Preferred Project
Report

2-32 Smith Street,
Summer Hill

Summer Hill Flour Mill
Site

26 March 2012

Figure 3: Internal separations between proposed dwellings

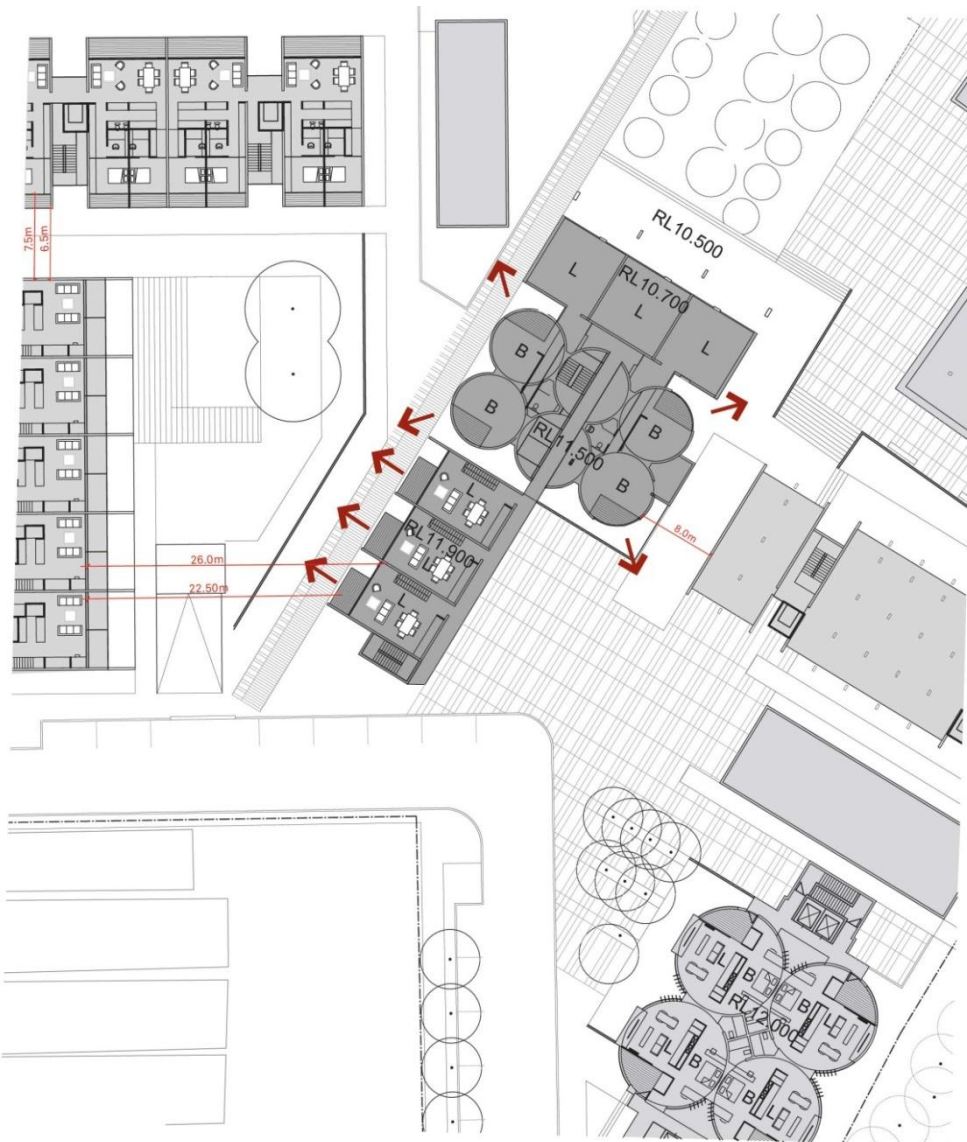
Pages 44 and 45 of the Concept Plan shows the internal layout of the two-bedroom apartments within the six pack silo building. Living rooms are accommodated within the new structure to the north of the bank of silos. The proposed balcony areas are recessed into the cylindrical forms and are configured such that any outlook to adjoining buildings within the development or on adjoining land are oblique views. This group of dwellings within the bank of silos effectively becomes part of the perimeter development created by buildings 5C, 5D and 5E. The central courtyard private open space area for this block provides the required level of separation recommended within the Residential Flat Design Code. These diagrams are reproduced below in Figures 1 and 2.

Figure 1 demonstrates that in the worst case a 20.0m separation is provided from balcony edge to balcony edge between the two (2) storey plus attic dwellings fronting Edward Street and the six (6) storey element behind the six pack of silos. The RFDC recommends separations between habitable rooms/balconies of 18.0m. This is readily achieved in the proposed layout.

Where the six pack of silos is separated by 8.0m from the rebuilt timber silo the internal layout demonstrates how the balcony of the silo apartment is off-set from this orientation and that the western wall of the re-built timber silo would not contain openings to habitable spaces.

Figure 4: Internal and external separations

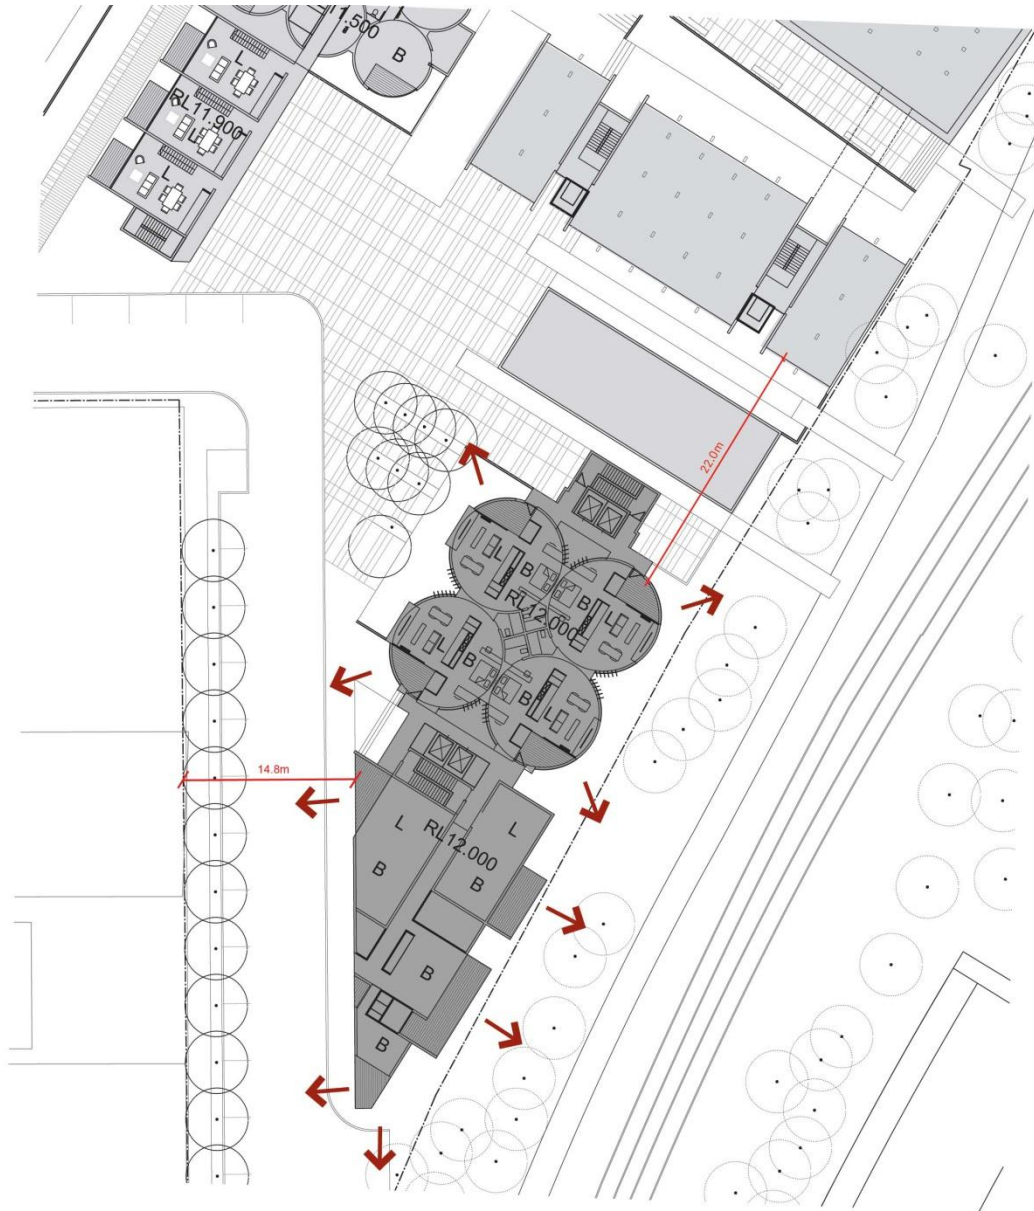
Figure 2 below demonstrates that the separation between the four pack silos proposed balcony edge and the southern elevation of the re-built timber silo is 22.0m. The RFDC recommendation for separations of habitable to non-habitable spaces is 18.0m. The separations are consistent with this guideline.

Figure 2 also demonstrates the separation between the balcony line of the seven (7) storey building to the south of the four pack of silos and the rear boundary of the properties fronting Edward Street to the immediate west. This setback is 14.8m. The RFDC recommends that the minimum separation between

buildings up to eight (8) storeys should be 18.0m between habitable rooms/balconies. This separation is typically shared between adjoin sites, with each site accommodating 50% of the separation. In this instance, 825 of the separation is accommodated on the site, resulting in no limitation on future development potential of these lands and ensuring more than adequate separation has been provided for.

Figure 5: Amended staging plan

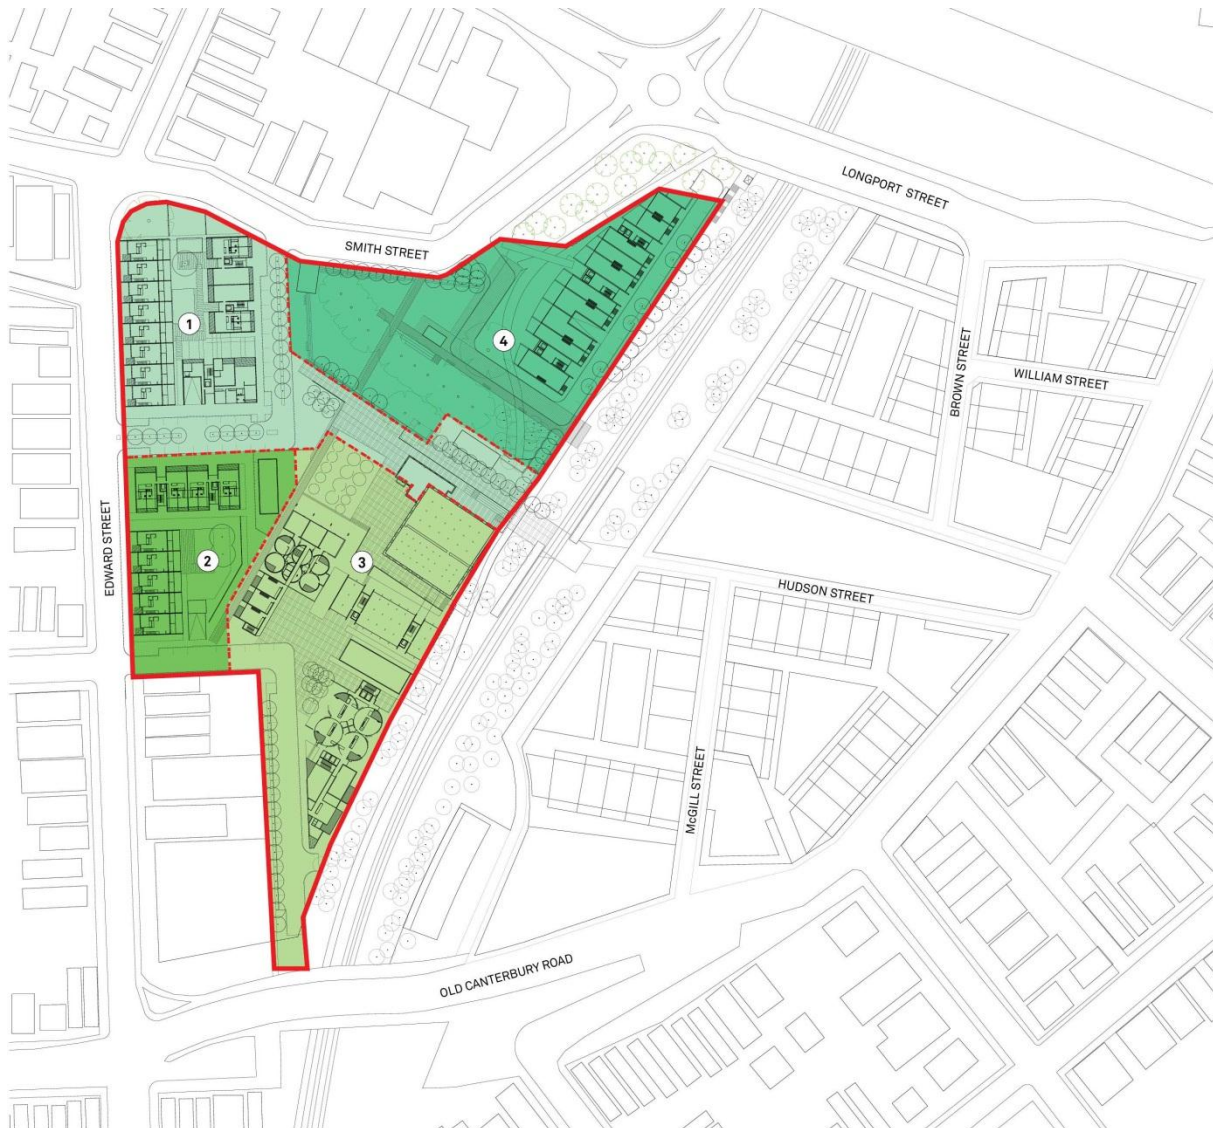
Agency	Response
	Stages 1 to 4.
Staging Plan	The staging has been amended to ensure the delivery of access to the light rail is provided in Stage 1. This includes the construction of the new street linking Smith and Edward Streets to service the proposed dwellings in the vicinity of the current administration building at the corner of Edward and Smith Streets.
Resolution of details prior to future project Application or Development Consent determinations	No works can be undertaken without the lodgement of further Development Applications which will involve input from Council for assessment and determination by the relevant Council.
s94 payments	The statement of Commitments includes an undertaking to make s94 contributions in accordance with Council's s94 Plan.
Supermarket	No supermarket is proposed in the development nor is there a sufficient sized area of retail space that could accommodate a supermarket. Further, there is no area that could be serviced by delivery vehicles required to operate a supermarket. The retail spaces are a maximum of 150-200m ² in area well below the requirements of a supermarket operation.

The staging plan lodged with the Concept Plan as exhibited proposed the provision of access through to the light rail stop adjacent to the Mungo Scott building within Stage 3 and the delivery of the landscaped open space dominated by the current avenue of trees off Smith Street in Stage 4.

The staging plan has now been amended to include the creation of the access through to the light rail stop within Stage 1. Stage 1 is now configured to provide publicly accessible linkages through the site from Edward Street and from Smith Street. To provide an attractive and functional linkage, Stage 1 now includes Building 1C and Building 2B which will include low scale retail uses to frame the access pathway and provide activity close to the light rail stop at the earliest stage possible.

The urban plaza to be created by the demolition of the bank of metal silos will be delivered as part of Stage 3. Stage 3 includes the redevelopment of the six pack and four pack of silos as well as the Mungo Scott building. This stage includes public open space plazas to the north and south of the six pack silos as well as a new street behind the Edward Street properties. This new street does not link through to Old Canterbury Road for vehicle traffic. Prior to the occupation of Stage 3 the signalisation of the Edward Street and Old Canterbury Road intersection is required.

The avenue of brush box trees and the landscaped setting which frames the original site access from Smith Street would be delivered as part of Stage 4 and which includes the largest concentration of residential dwellings.
